Weld Re-5J School District
2020-24 Capital Construction Program
110 Centennial Drive, Unit A
Milliken, CO 80543

ADDENDUM #1

TO: Weld Re-5J School District, Professional Land Survey Services
RLH Engineering Project Number 20080

SUBJECT: Addendum Number One

Potential Locations being Considered for the Development of the New Re5J High School

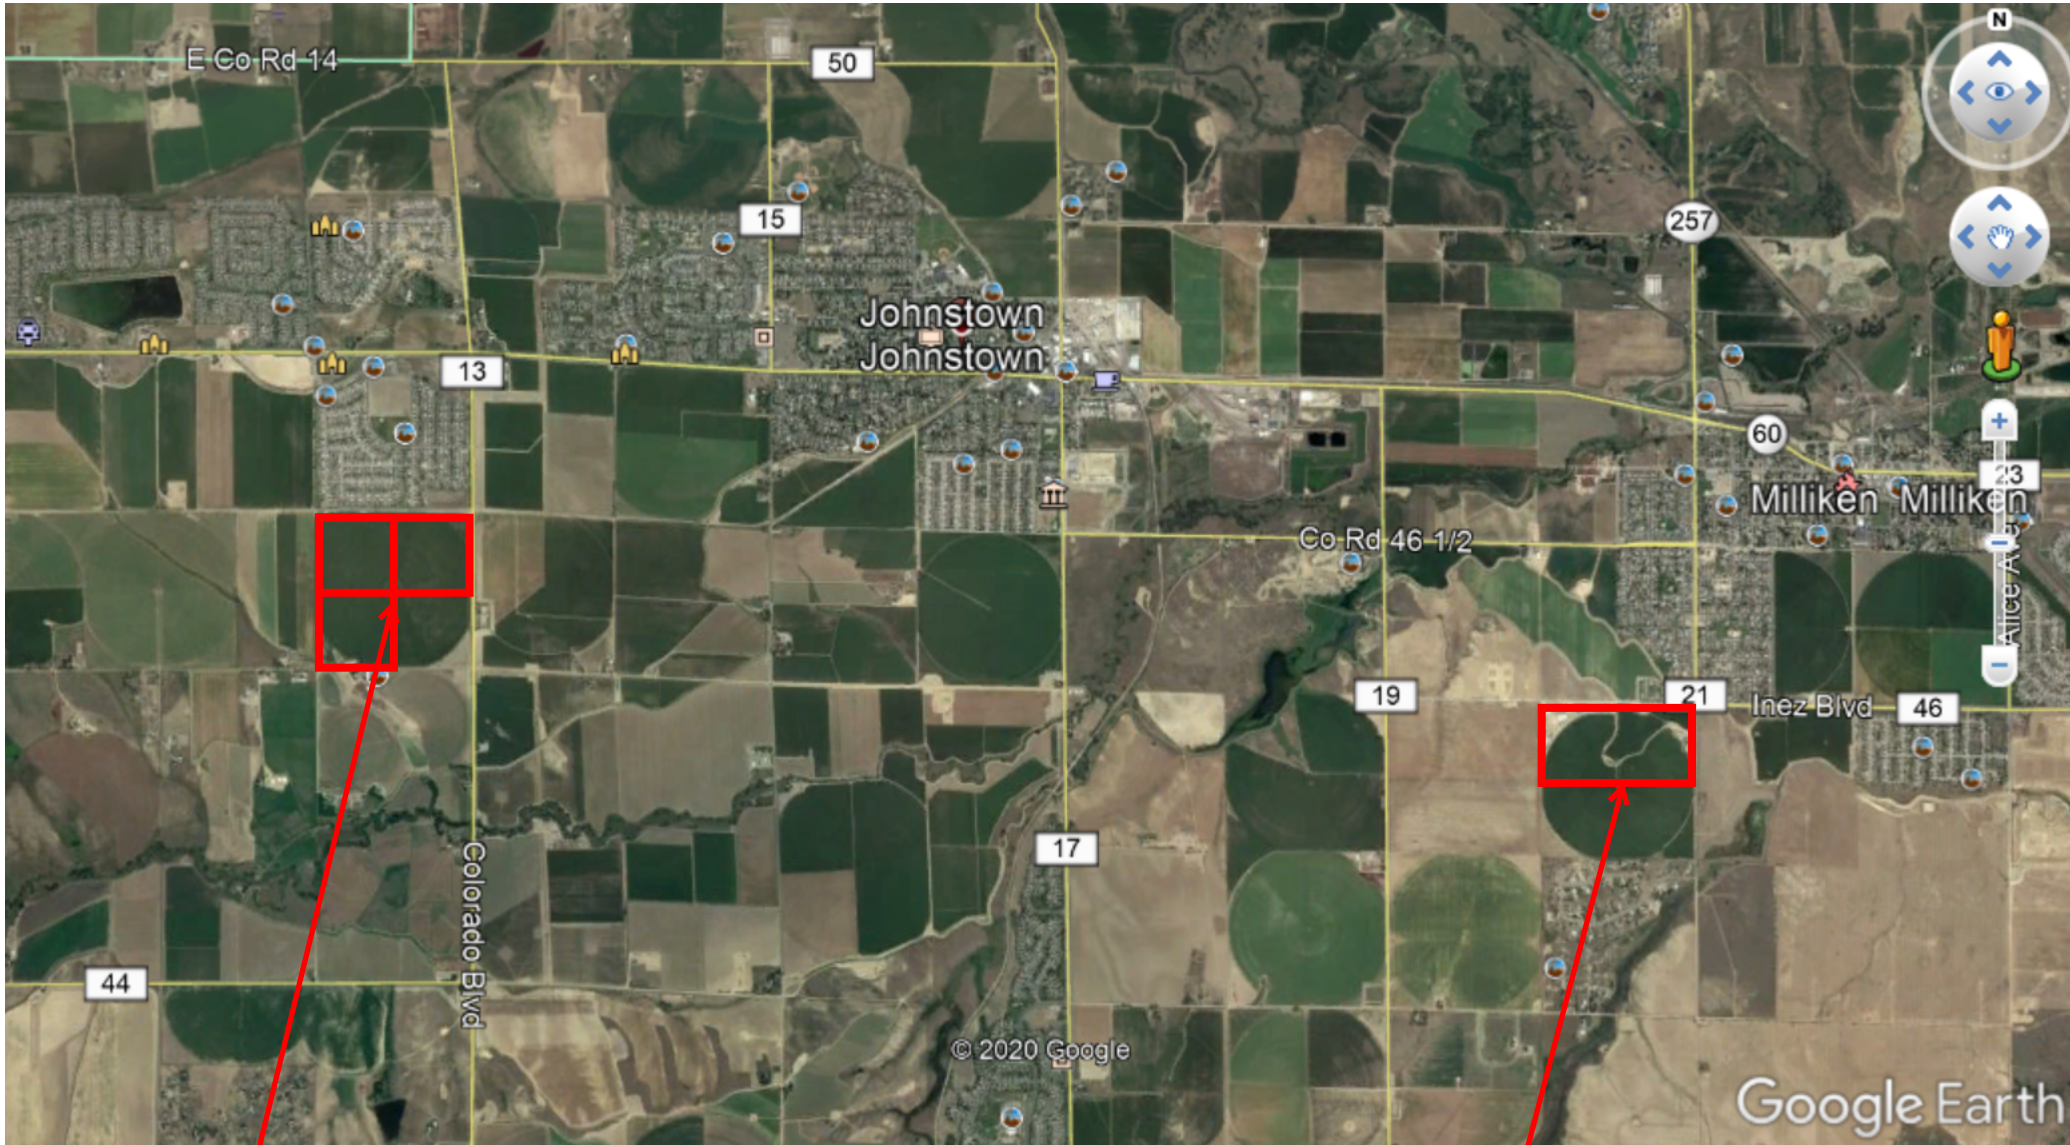
5. Question: On pages 3 and 4 the RFP references “attached site photos” or “attached site images” but none are included in the PDF, can you please provide site photos/property limits?

Answer: Please refer to the site photos have been attached to this Addendum #1.
